Memorandum to the City of Markham Committee of Adjustment

File: A/130/21
Address: 8 Galsworthy Drive – Markham, ON
Applicant: Mark Li
Agent: Yinghuan Weng
Hearing Date: November 10, 2021

The following comments are provided on behalf of the East District team. The applicant is requesting relief from the following “Residential One – (R1)” zone requirements under By-law 1229, as amended, as they relate to a new two-storey detached dwelling. The variances requested are to permit:

DRAWING: Site Plan

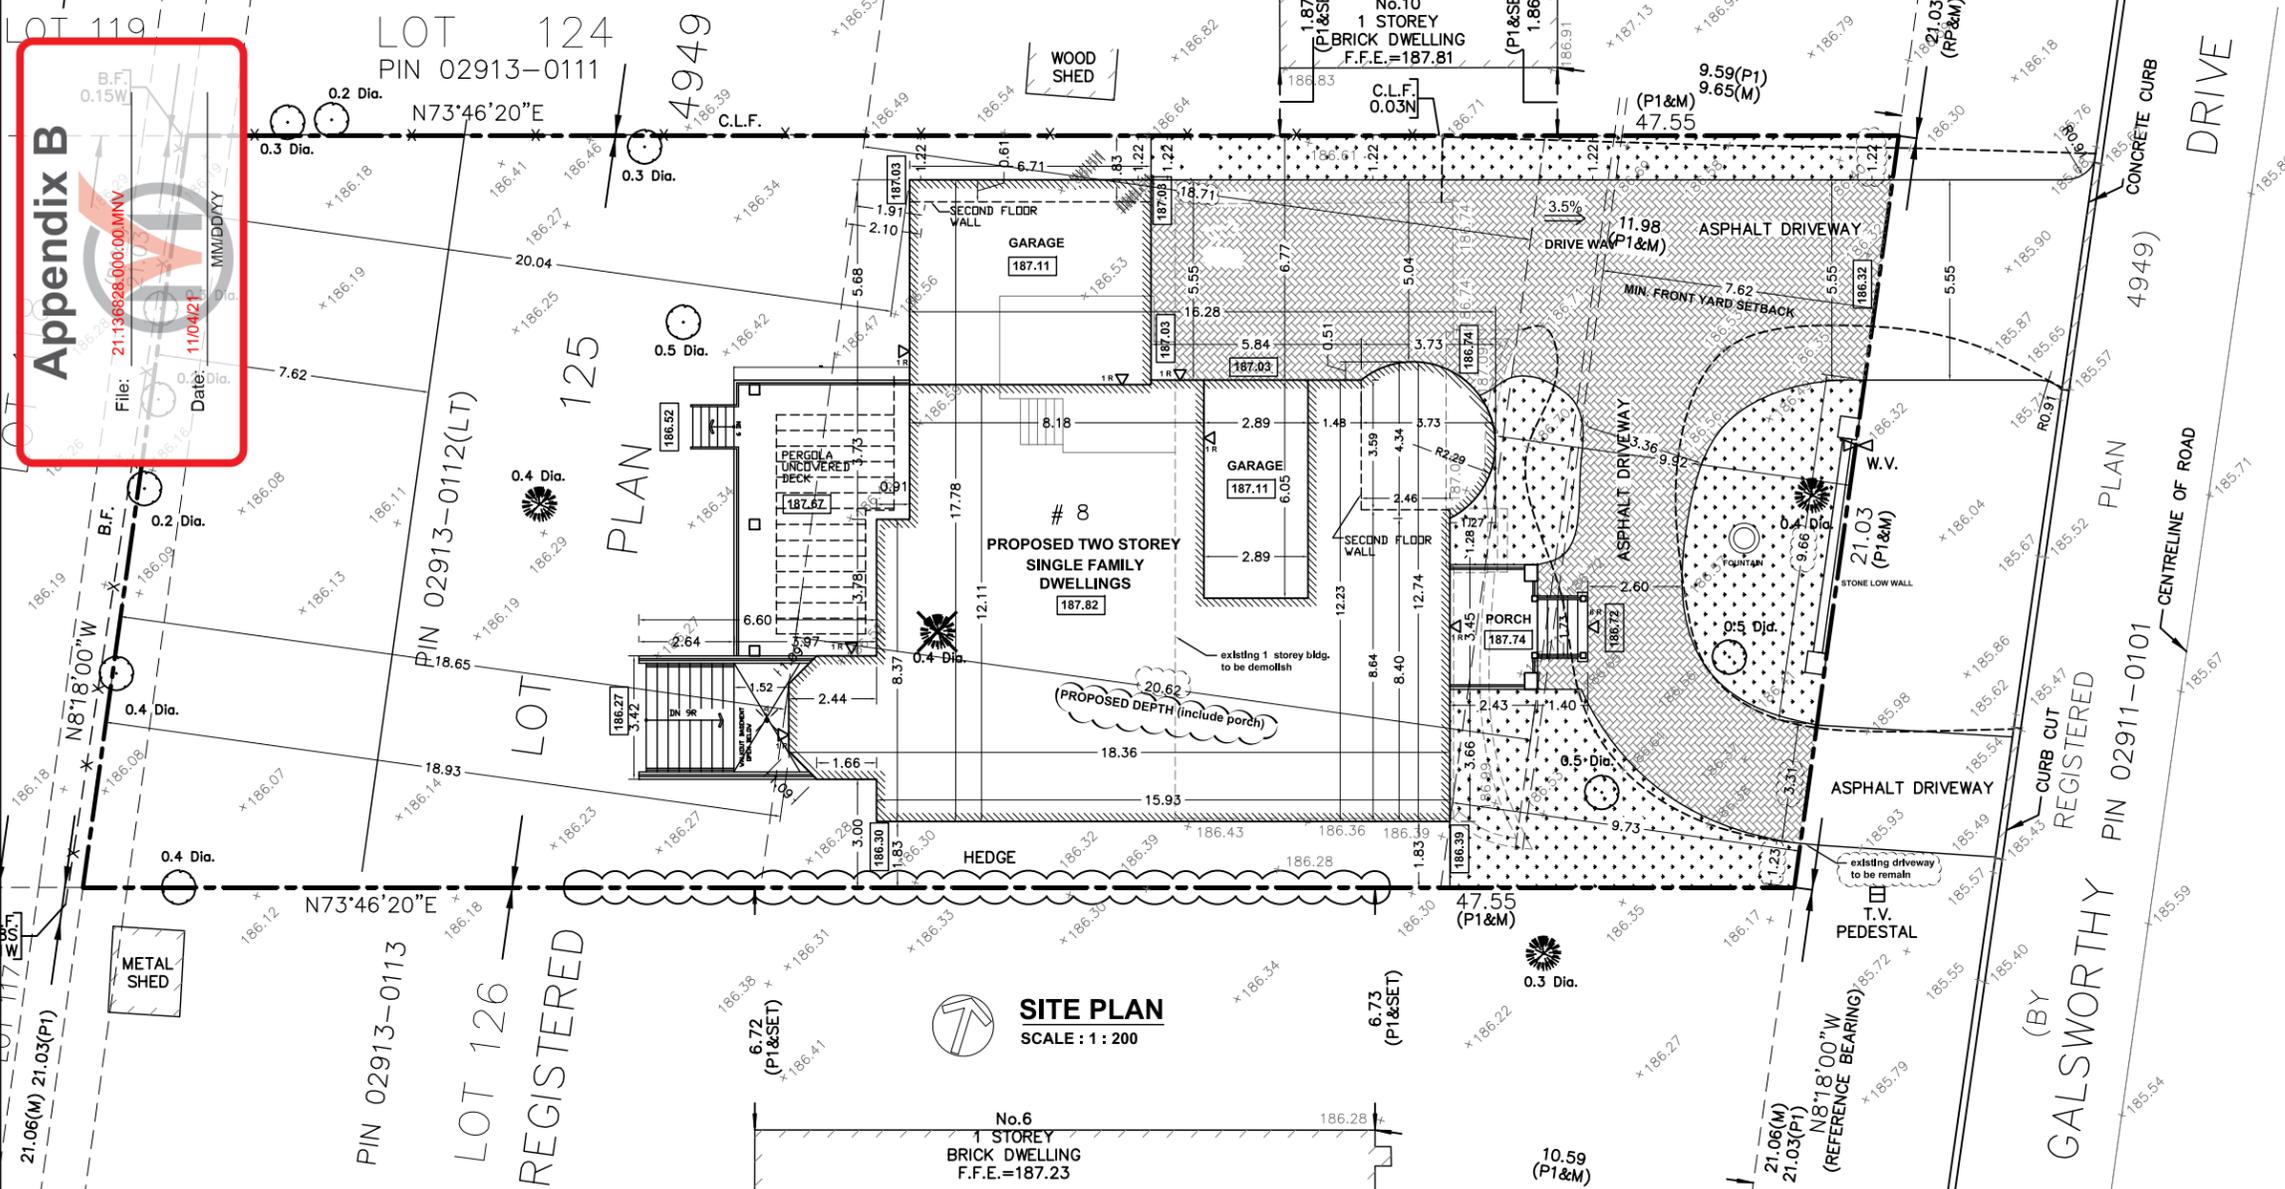
As the property's front and rear lot lines are angled, the building depth measures 20.62 m (67.65 ft) as shown in the Site Plan (Appendix "B"). Staff are of the opinion that the rear balcony appropriately maintains the intent of the By-law, as it generally meets the criteria for extensions. Staff have also given consideration to other elements which assist in breaking up the mass of a building, including stepbacks, setbacks, and the location of the front covered porch which extends beyond the maximum permitted building depth. Staff have no objections to the requested variance.
